MANAGER'S REPORT NO. 37
COUNCIL MEETING May 14/73

11. Re: Letter dated April 30, 1973 from Mr. T. Schultz, 1557 Specling Avenue

Driveway, Crossing and Lack of Traffic Lights on Sperling

SECTION VIEW OF CURE DEOF.

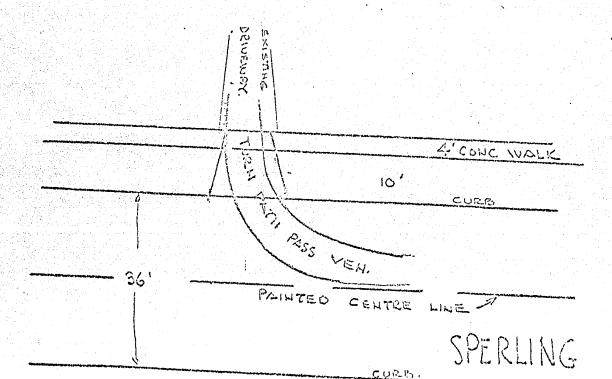
Appearing on the Agenda for the May 14, 1973 Council meeting is a copy of a letter dated April 30, 1973 from Mr. T. Schultz questioning his driveway width and commenting on the lack of signalized intersections on Sperling Avenue between Hastings and the Lougheed Highway.

Before the installation of concrete curbs, Sperling Avenue consisted of a 20' cap pavement with fairly wide gravel shoulders on which to park. There was an existing four foot wide concrete sidewalk in front of the complainant's address with a scored vehicular crossing that measured 10' at the back of the walk and 12' at the front. The new curb drop was matched to the existing sidewalk crossing and measures 12' across the base. This dimension of crossing is the minimum standard provided for residential driveways. A plan attached indicates the driveway in question and the turning path of standard American passenger vehicles. As noted, access can be accomplished without crossing the centre-line.

THAT the curb cut be widened to a 15' foot crossing at the "base".
